Draft Interim Review of PRM-50-93/95 Issues Related to Minimum Allowable Core Reflood Rate

This report is the U.S. Nuclear Regulatory Commission (NRC) staff's interim evaluation of certain assertions in petition for rulemaking PRM-50-93/95 regarding the stipulation of a minimum allowable core reflood rate as part of the regulations.

Figure 1. Initial Clad Temperature Effect of Temperature Rise and Quench Time. (Figure 3-23 from Lee et al. (1982))

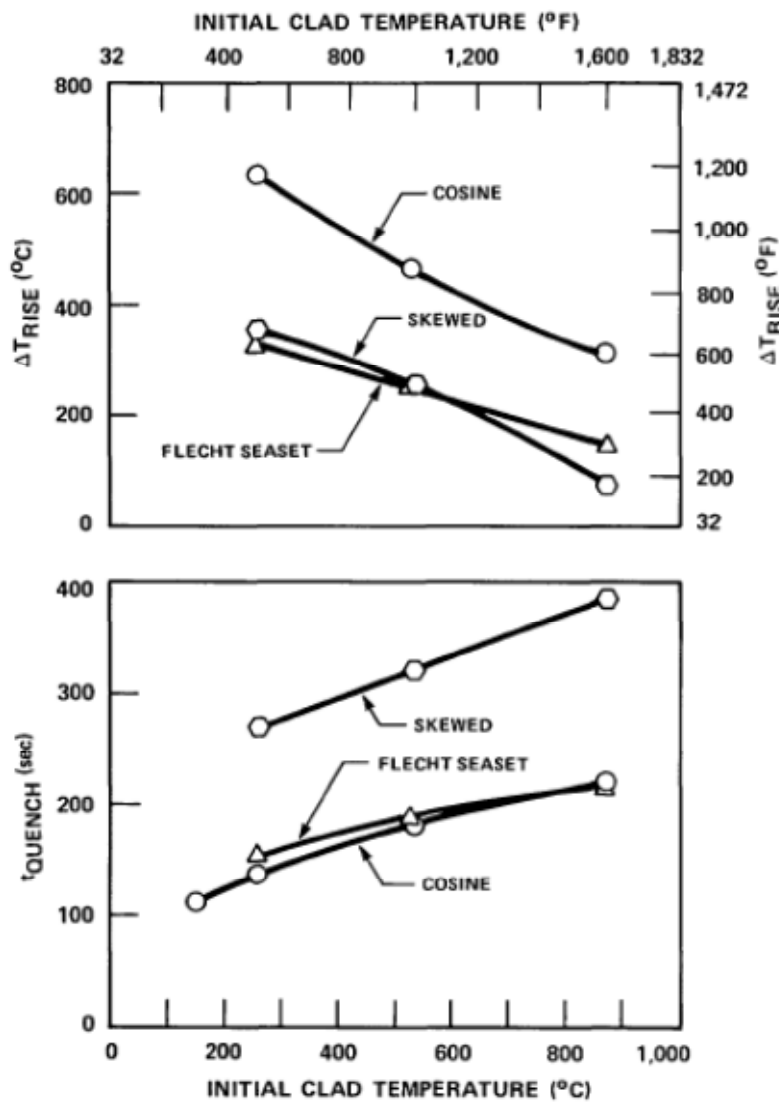
conclusion on any single parameter can be misleading. Part of the basis for the petition's request for a limit on reflood rate, is the significant temperature increases observed in the NRU reflood tests. Starting from initial cladding temperatures less than 1000 degrees F, several NRU tests produced temperature increases of over 1000 degree F. The petition cites NRU test 127 and 130 as examples. The petition appears to imply that similar temperature increases would occur if the initial cladding temperatures had been 1200 degrees F or more. This is not correct, however. Thermal radiation becomes more important in transferring heat away from hot spots, and as rod temperatures increase the temperature difference between the cladding and the coolant increases. Figure 1, from Lee et al. (1982), shows the effect of initial cladding temperature on temperature rise from tests in three experimental facilities. As the initial cladding temperature increases, the overall temperature rise decreases. Thus, contrary to the claim made in the petition, "extrapolation" of data does not show "with high probability" that peak cladding temperatures will exceed 2200 degrees F.

The FLECHT, FLECHT Top-Skewed Power, and FLECHT-SEASET results shown in Figure 1 were not conducted with Zircaloy as the cladding material. Thus, there remains a possibility that as the cladding temperature exceeds 1000 degrees C (1832 degrees F) and the metal-water reaction rate becomes significant, this might increase the overall temperature rise in the bundle. While the NRU bundle did have Zircaloy cladding, the initial cladding temperatures were generally lower than those in counterpart experiments in other facilities, as noted in the petition. To examine the effect of initial cladding temperature on reflood where metal-water reaction is a concern, a sensitivity study was conducted using TRACE with simulations of FLECHT Test 9573. As noted previously, FLECHT Test 9573 had a forced reflood rate of 1.1 inch/sec (0.02794 m/sec). But, because it initiated with an initial cladding temperature of 1970 degrees F, temperatures quickly exceeded 2200 degrees F, damaging the bundle. TRACE simulation of Test 9573 showed reasonable agreement with available data, with TRACE exceeding the measured maximum cladding temperature 18 seconds into the test. (After 18 seconds, thermocouples began to fail and the data is suspect.) At the 6-foot (1.83 m) elevation, the measured cladding temperature was 1513.5 K (2264.6 degrees F). TRACE predicted 1554.2 K (2337.9 degrees F) using the Cathcart-Pawel (1977) correlation for metal-water reaction.

Figure 2. Sensitivity of Peak Cladding Temperature to Initial Cladding Temperature in a Simulated Zircaloy Clad Rod Bundle.

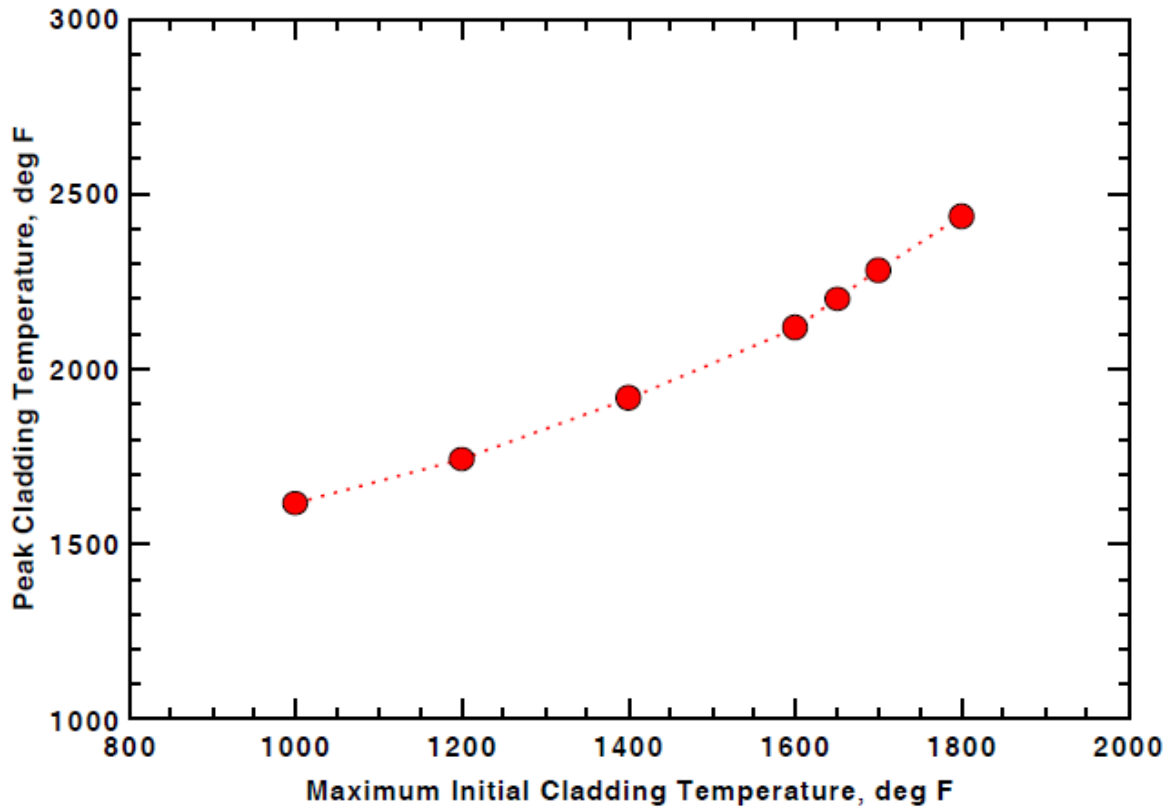
Figure 2 shows the results of the sensitivity of peak cladding temperature for the bundle used in FLECHT Test 9573 experiments with initial cladding temperature. In each case, the initial axial cladding temperature profile was scaled to that of Test 9573 to obtain the desired maximum cladding temperature at the start of each simulation. The reflood rate was assumed to be 1.1 inch/sec, consistent with Test 9573. At maximum initial cladding temperatures less than approximately 1200 degrees F (922 K), typical of those expected following the blowdown period of a LOCA, the peak cladding temperature remain below 1800 degrees F (1255 K). The predicted peak cladding temperature did not exceed 2200 degrees F (1477 K), unless the maximum initial cladding temperature was greater than 1600 degrees F. This is significantly higher than the initial temperatures that are expected to occur following the blowdown and refill periods of a LOCA.

The reflood rate simulated in the calculations for Figure 2 was 1.1 inch/sec, in order to be consistent with the rate used in the actual experiment. Clearly, if coolant is denied to a rod bundle during reflood, the cladding will increase in temperature rapidly. The rate at which the cladding temperature increases depends on several parameters, as does the peak cladding temperature that is attained during a transient. As discussed previously, the peak cladding temperature depends on numerous other parameters including the rod power, coolant temperature, and pressure. This is because the temperature at a particular location on a rod depends on an energy balance. Ultimately the peak temperature depends on the local heat generation (decay heat from the fuel and metal-water reaction heat) and heat removal mechanisms (conduction away from the hot spot, convection to the coolant, and thermal radiation to the coolant or colder structures). Indeed, it is possible to cool a bundle and prevent the peak cladding temperature from exceeding 2200 degrees F (1477 K) with a zero reflooding rate if sufficient cooling is provided by other means.

Figure 3. TRACE Simulation of Steam Cooling of a Zircaloy Bundle. (Mass flow rate = 0.114 kg/s, saturated steam at 0.42 MPa.)

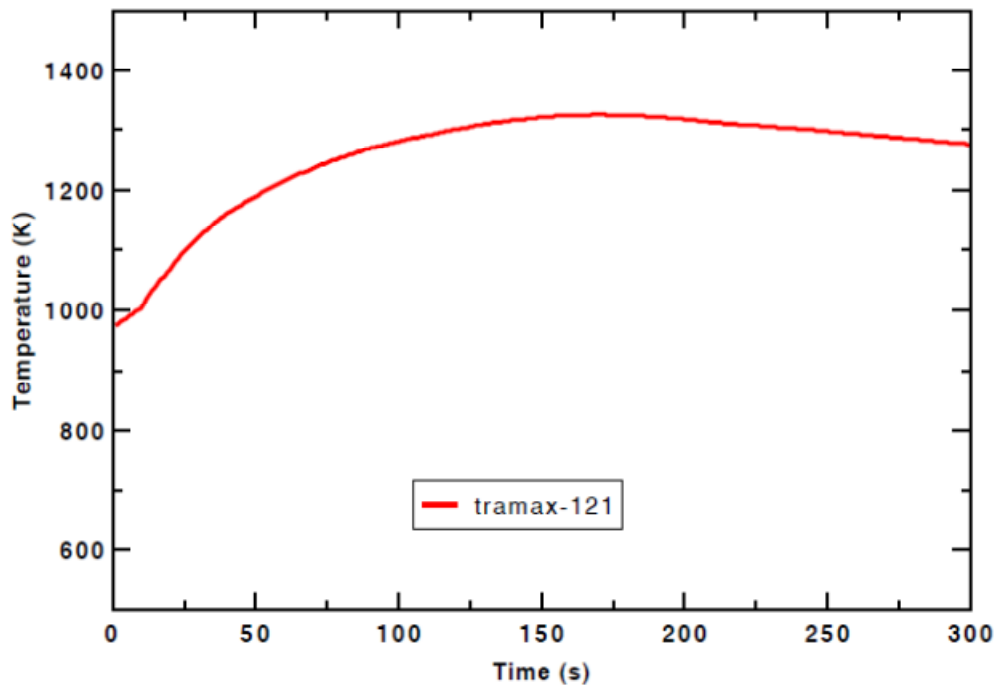
Consider the TRACE model of the Zircaloy clad bundle that represented the bundle used in FLECHT Test 9573. Assuming an initial temperature profile with a maximum temperature of 1200 degrees F (922 K), a simulation was conducted with no liquid injection but with steam-only cooling of the bundle. Figure 3 shows the maximum cladding temperature as a function of time for a steam-only mass flow rate of 0.114 kg/s through the bundle. The peak cladding temperature obtained 1325.7 K (1927 degrees F). No liquid injection can be interpreted as a reflooding rate of 0.0 in/sec. Cooling was accomplished not by reflood of the bundle, but only by convective cooling to the steam. The cladding exceeded 1000 C (1832 degrees F), and thus

metal-water reaction became a significant source of heat. Nevertheless, the peak cladding temperature remained below 2200 degrees F and an “autocatalytic” (runaway) oxidation did not occur.

The steam-only cooling calculation demonstrates that it is possible to cool a Zircaloy clad bundle without reflooding. Adequate cooling could be obtained by alternative heat transfer mechanisms. This indicates that specification of a minimum reflood rate, as requested by the petition, is not necessary. As long as sufficient cooling by the Emergency Core Cooling System (ECCS) is maintained, the peak cladding temperature can remain below the regulatory limit of 2200 degrees F (1477 K).

Figure 3 demonstrates that the argument central to the petition’s request that a minimum reflood rate be specified, is false. The petition’s claim is:

Figures 3 showed that if FLECHT Test 9573 were repeated with the same power level, the bundle would not have been destroyed as long as adequate cooling was maintained. The reflood rate is irrelevant. Thus, the results of the calculations presented in Figures 2 and 3 also demonstrate that the petition’s claim that “it can be extrapolated from experimental data that, in the event a LOCA, a constant core reflood rate of approximately one inch per second or lower
